Access Compliance Report

Public Rights-of-Way

(Pedestrian Signals)

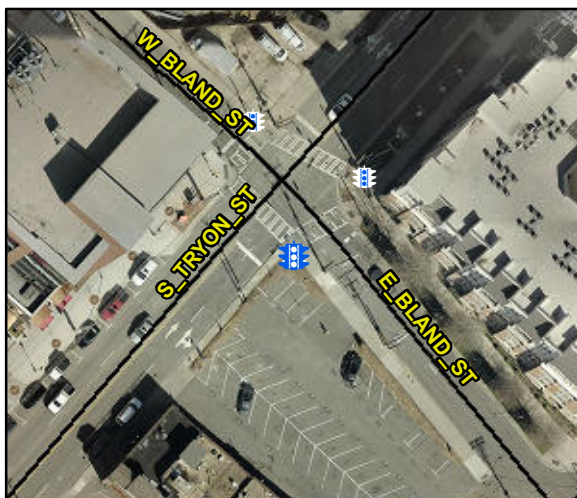
Intersection ID: N/A	Main Street:	Cross Street: N/A	Location: N/A
ADA ID: 11F4F37595EF	Signal Type: One Push Button-Non APS	Overall Compliance: No	Severity Score: BTN 1: N/A BTN 2: N/A No BTN: N/A
Codes/Mitigation Info/Possible Solution		Field Measurements/Component Compliance

PROW/ADA: TMUTCD 4e.08, R406.2

Possible Solutions: Replace Signal Push Button With APS Button on New Post. Remove & Relocate Sign.
